Sub-Regional RTEP Committee PJM South

SRRTEP - South
December 1, 2016

PJM Baseline Project B2185 Update

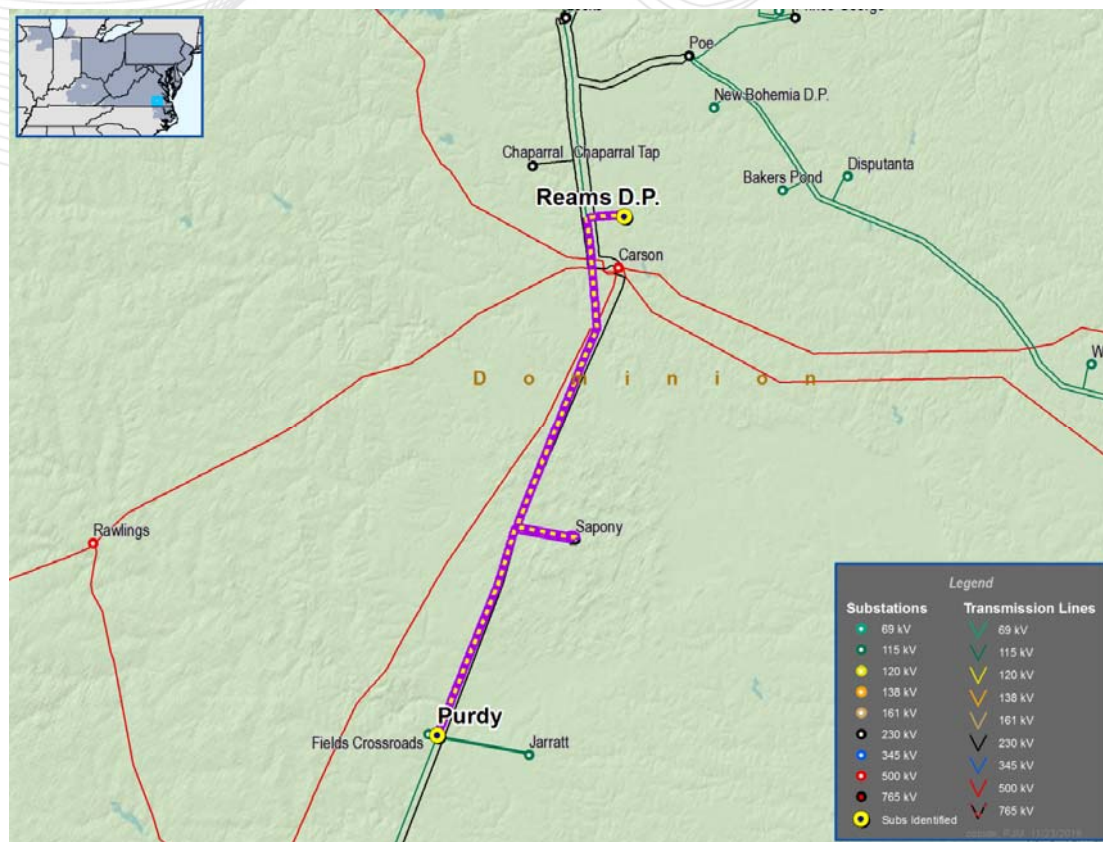
Problem: NERC Category B Violation (DVP Analysis)

- The 2017 summer base case indicates that an outage of Line #69 breaker at Locks overloads Line #69 segment Reams DP to Purdy 115kV by 3% after 69T148 is closed and the load is fed from Clubhouse.
- The overload is created when Center Star DP (SEC) is converted from 34.5kV to 115kV and transferred to Reams DP in 2017.

- Uprate Line #69 segment Reams DP to Purdy (19 miles) from 41 MVA to 162 MVA by replacing 5 structures and re-sagging the line from 50 to 75C.

- Desired ratings have been achieved by updating engineering documents upon further review. B2185 will be cancelled since the approved scope was not needed to achieve the desired rating.

Existing B2719.1 - .3 Cost Increase Continued

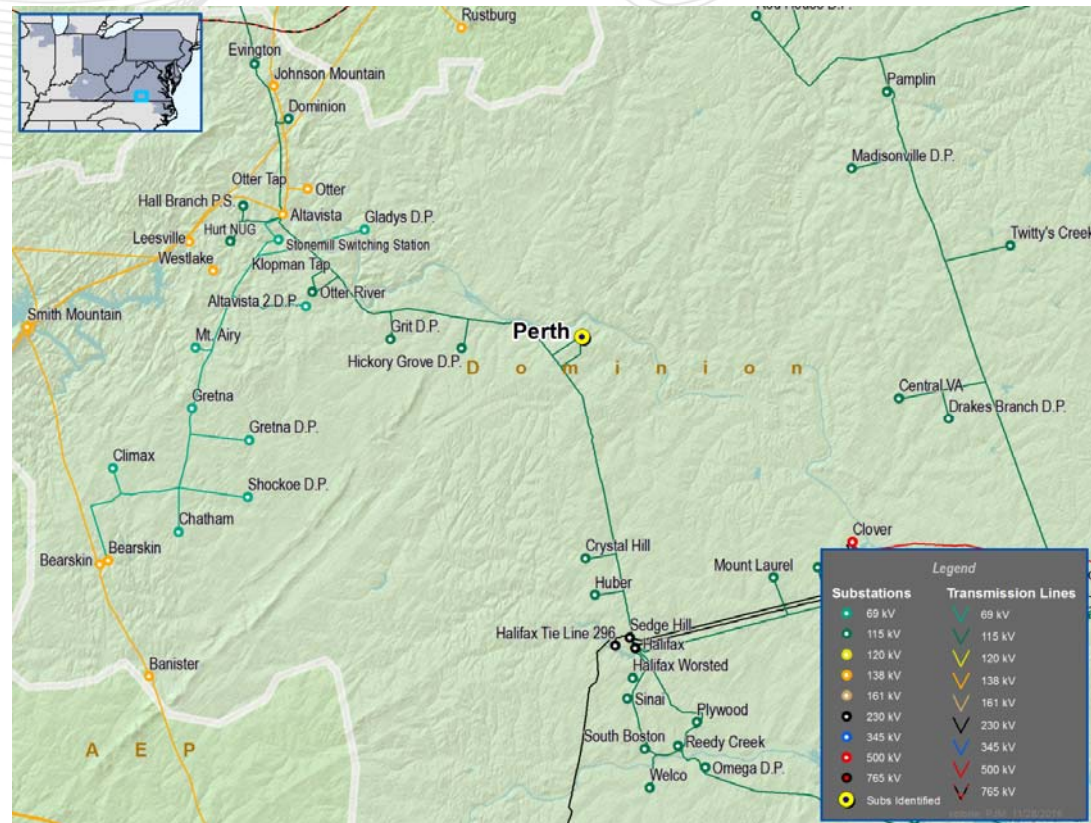
- The cost increase is due to a high level preliminary planning cost estimate versus a detailed cost estimate.
- The cost increase included \$100,000 for a mobile transformer required to serve the distribution load that has no external ties.
- The date was changed from June to December due to the mobile transformer ratings limitation during the late spring and early summer time frame.

Revised Estimated Project Cost: \$8.2 M

B2654.1 - .3 Cost Increase and Scope Modification Continued

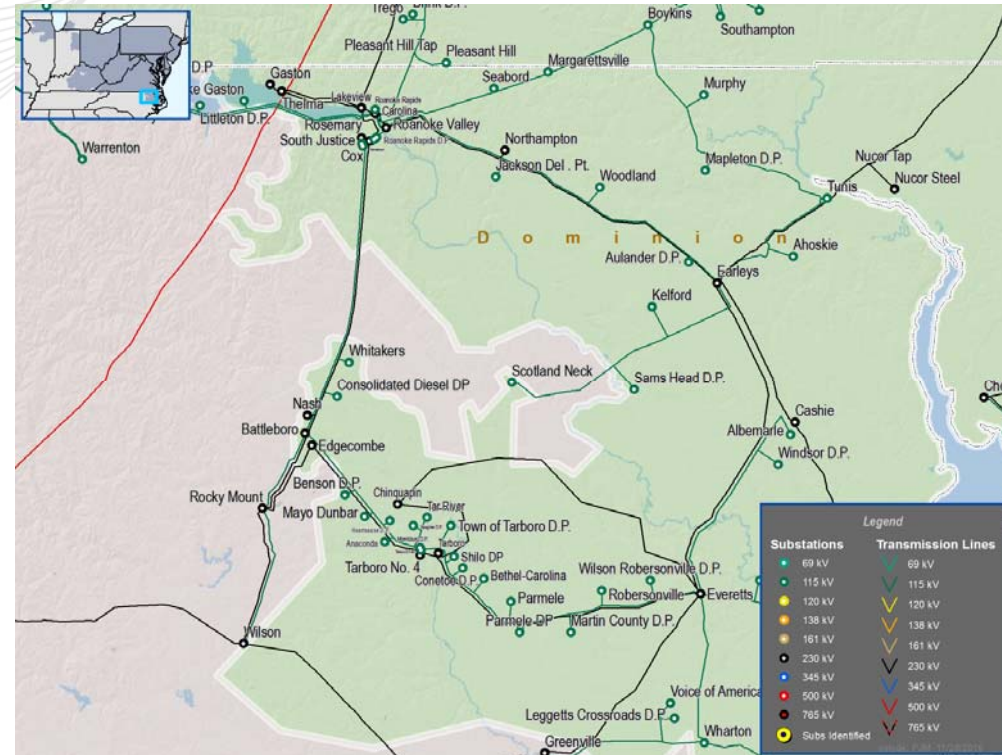
- Final routing increased the line mileage from 15 to 16 miles from Scotland Neck to South Justice Branch.
- Summer emergency rating target changed to 346 MVA from 262 MVA.
- Install an additional 115kV breaker in the breaker ring at S Justice Branch for a total of four 115kV breakers in the ring for breaker failure reliability.
- The cost increase is due to refined detailed cost estimate updates and the increased line mileage for the final routing.

Revised Estimated Project Cost: \$ 46.0 M

B2653.1 - .3 Cost Increase and Scope Modification Continued

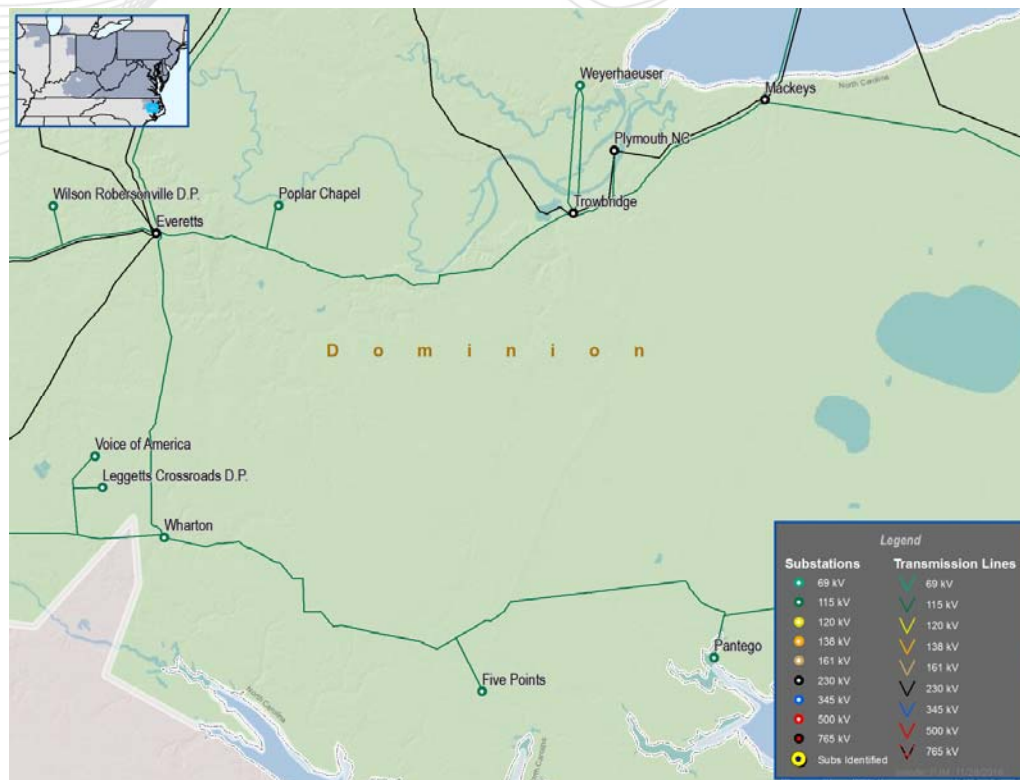
- Final routing increased the line mileage from 20 to 22 miles from Pantego to Trowbridge
- Summer emergency rating target changed to 346 MVA from 262 MVA
- Install an additional 115kV breaker between the four breaker ring at Pantego and the tap to Tideland EMC's Mattamuskeet DP for system protection requirements
- The cost increase is due to refined detailed cost estimate updates and the increased line mileage for the final routing.

Revised Estimated Project Cost: \$ 44.6 M

Existing B1794 Cost Increase

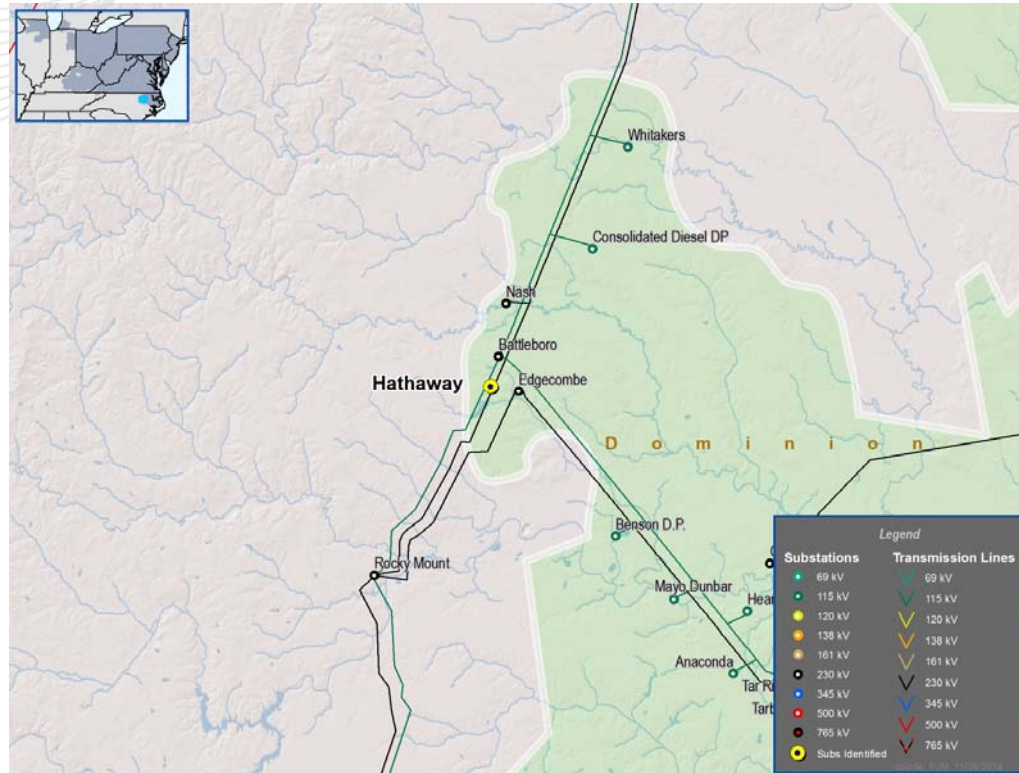
- The cost increase is due to additional substation expense, cost of land, expense for storm drainage and escalation of material and labor costs.

Revised Estimated Project Cost: \$ 25.4M

Existing S0602 Cost Increase

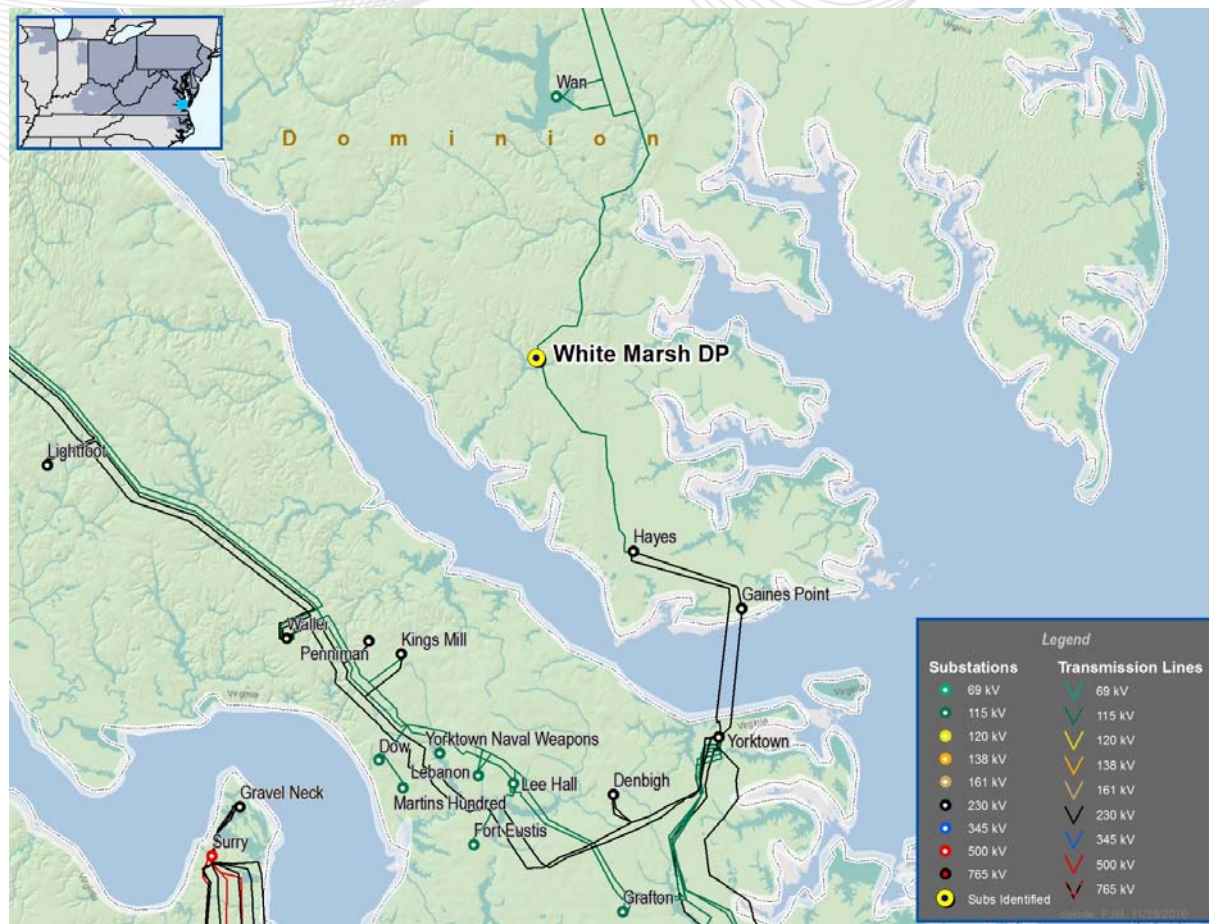
- Increase due to required installation of two steel dead end structures, two steel static poles and one switch structure at site.

Revised Estimated Project Cost : \$1.7 M

Existing S0920 Cost Increase

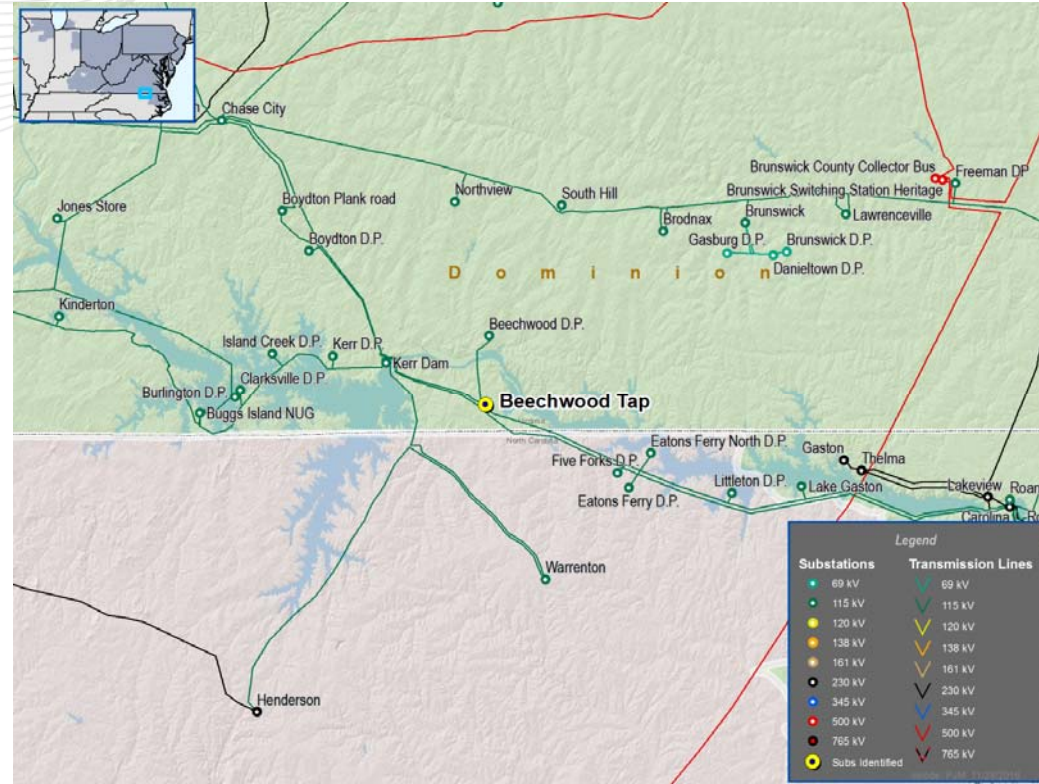
- Added cost for transmission line rearrangement which includes 3 backbones and modification of an existing structure for the new switching station.

Revised Estimated Project Cost: \$7.4 M

Existing S0610 Cost Increase

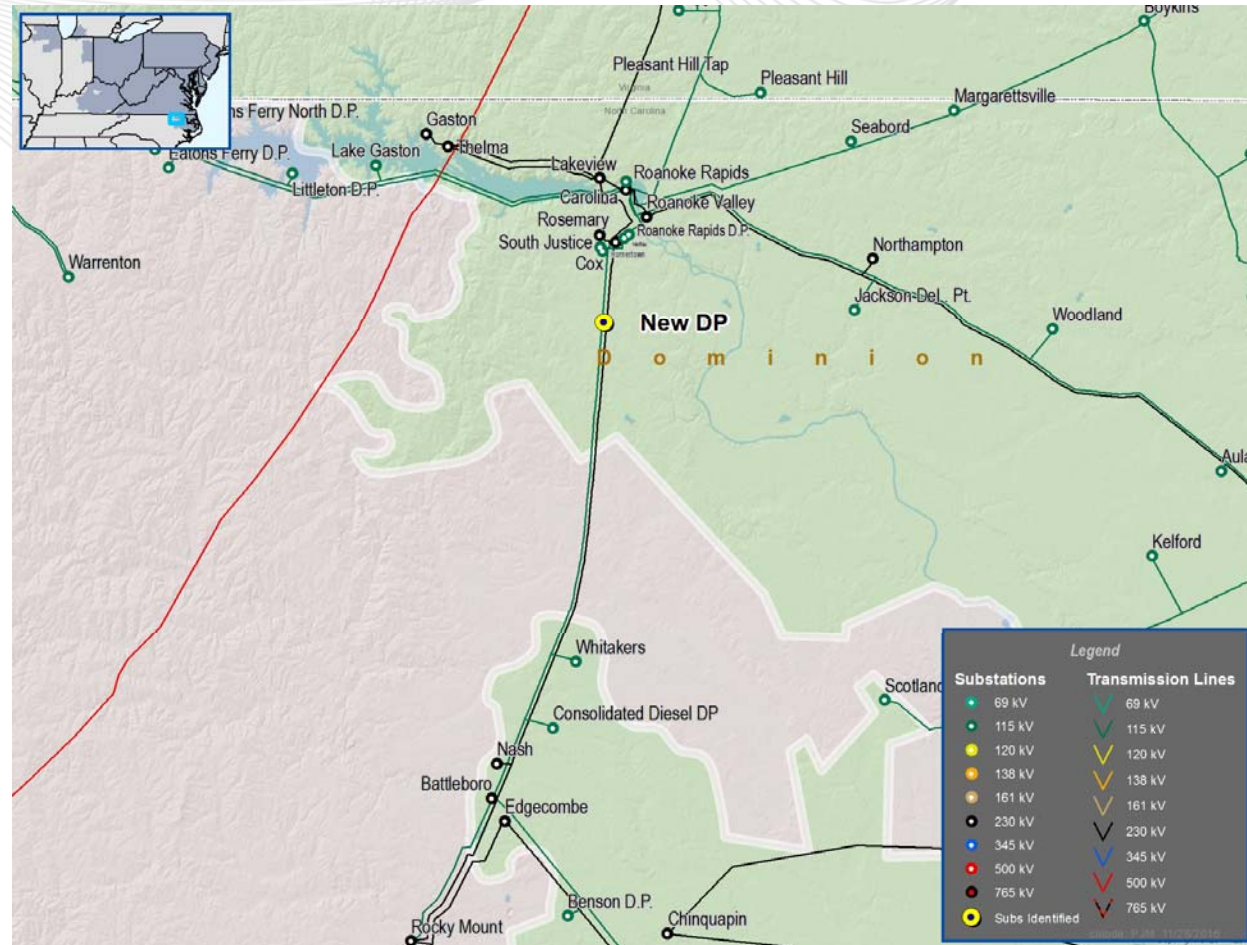
- Modification to the scope of work and timing of the Delivery Point
- Detailed estimated versus ballpark
- Retirement of Halifax DP switches

Revised Estimated Project Cost: \$ 2.0 M
